WILLIAMSON COUNTY, TEXAS

CHANGE ORDER NUMBER: 2

Project: T5045

Roadway: CR 404

TAKE OFF

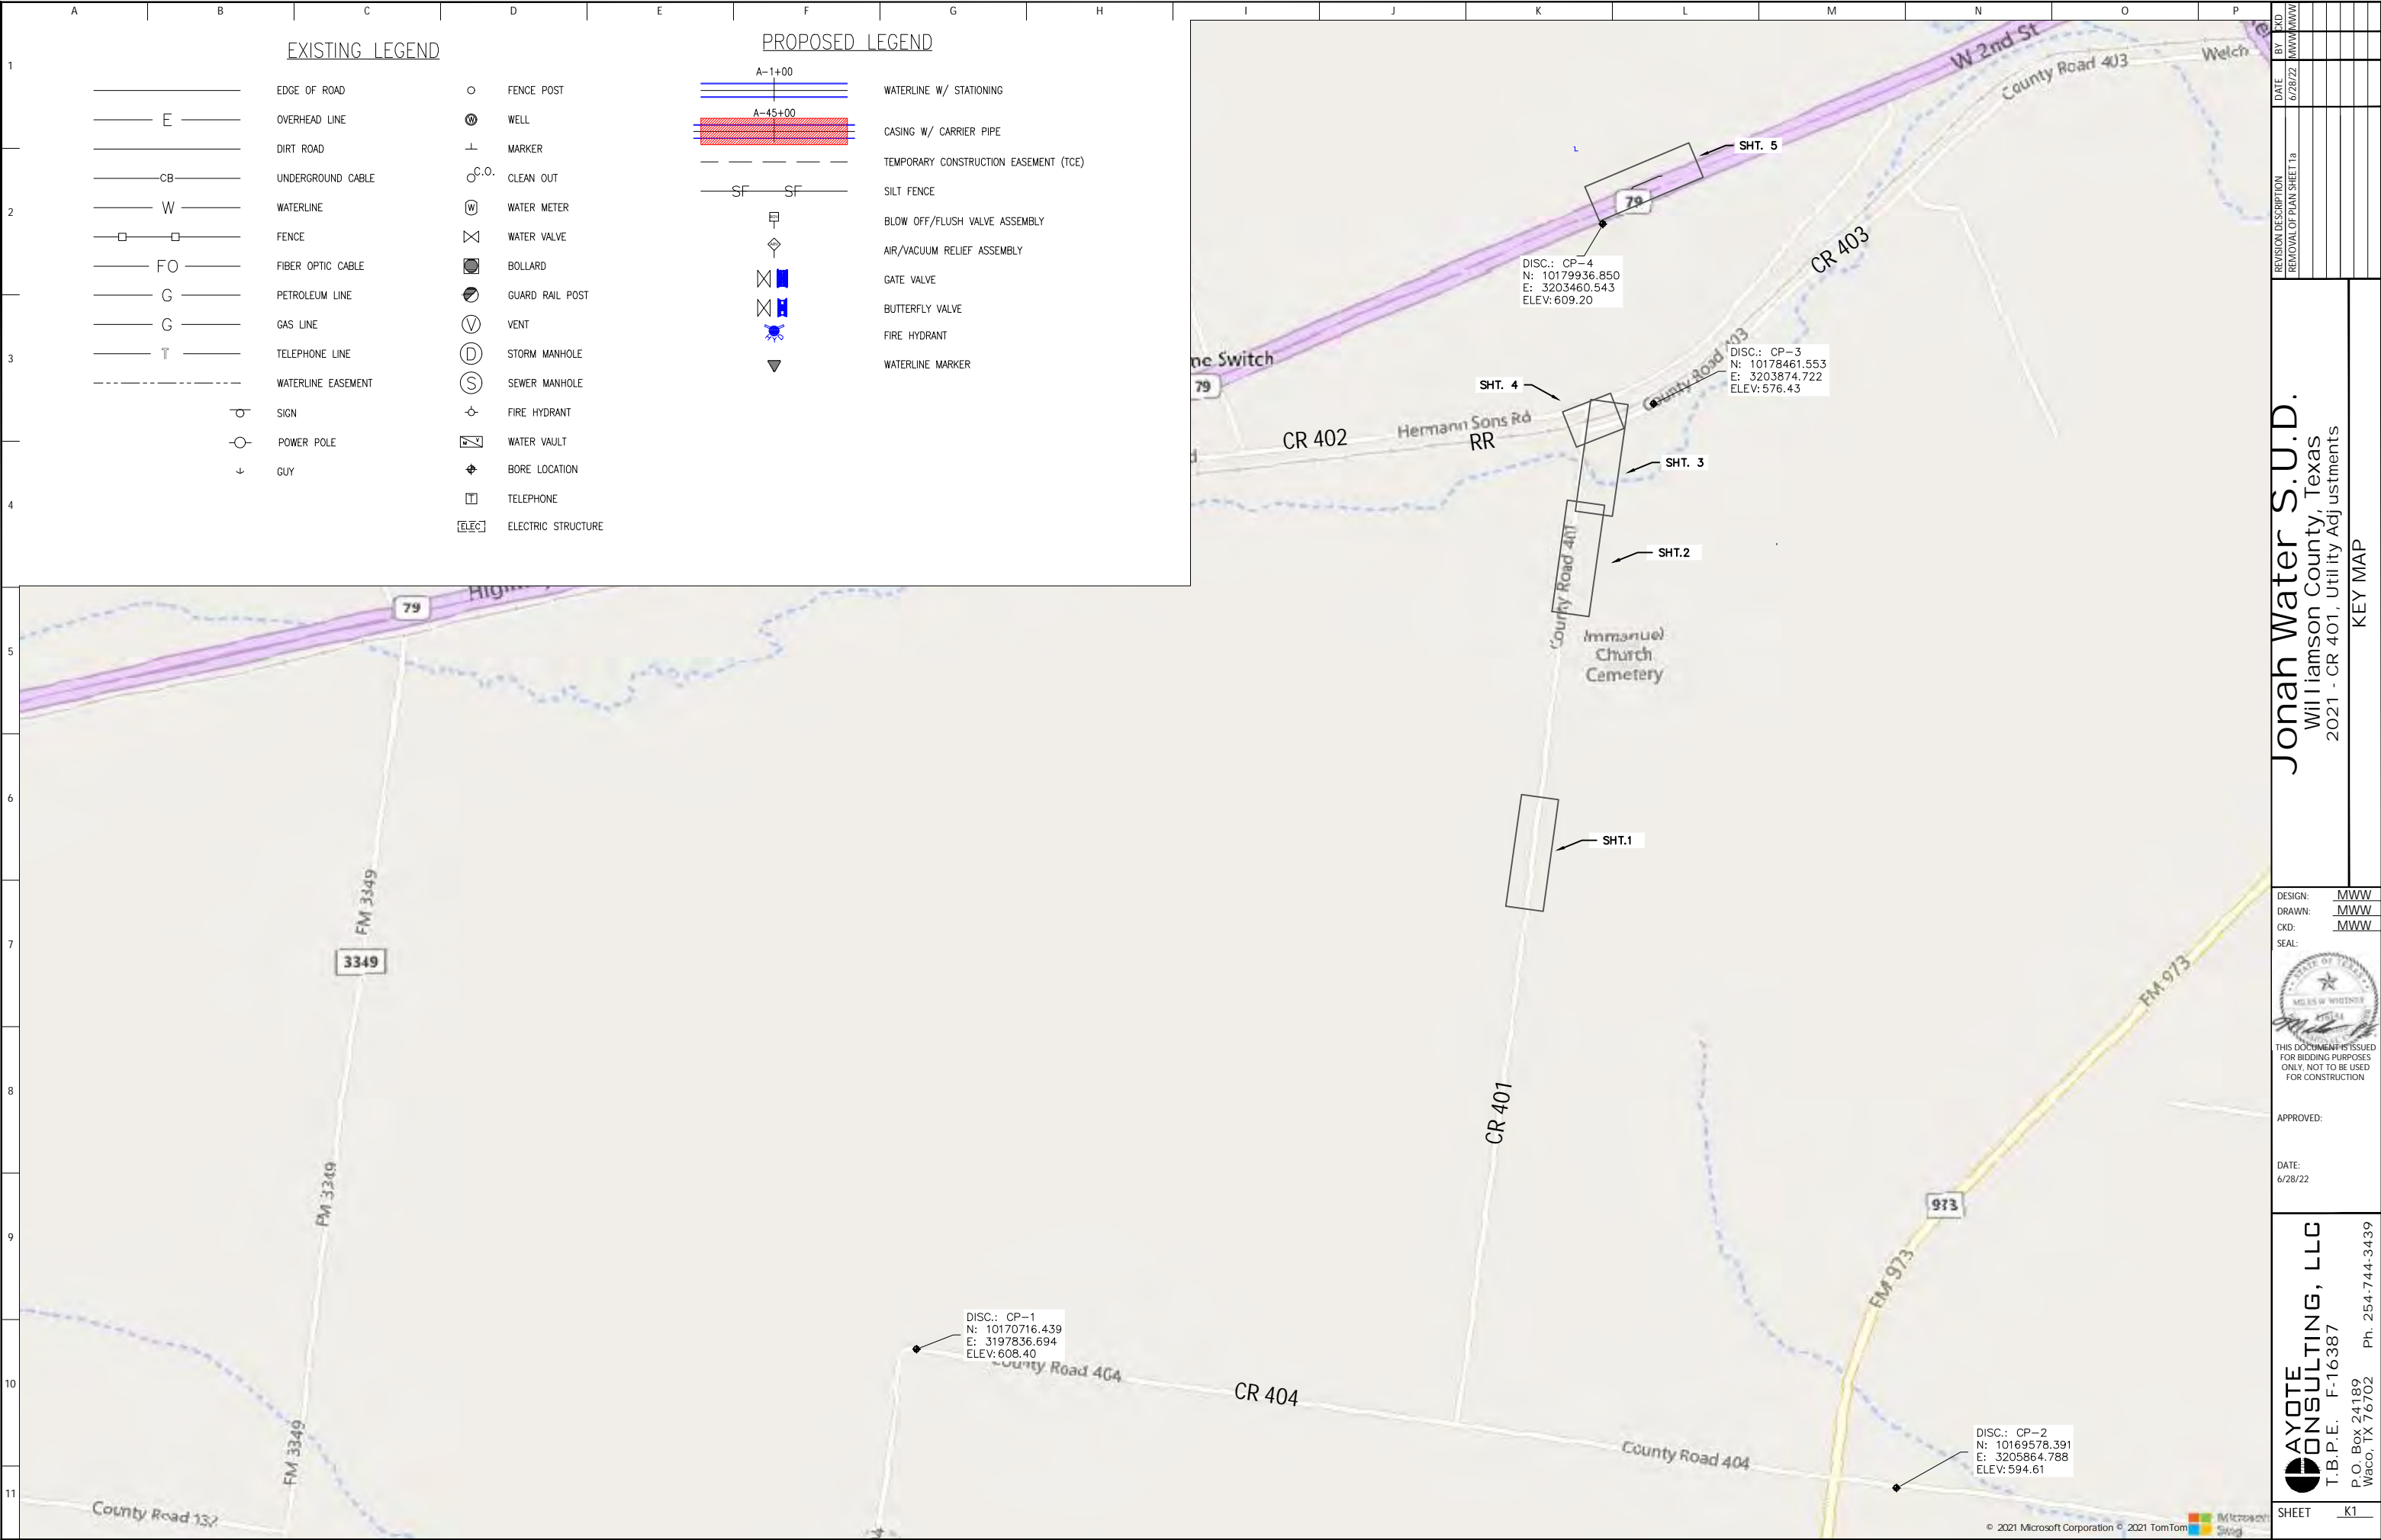
REVISION DESCRIPTION

UPDATED QUANTITIES
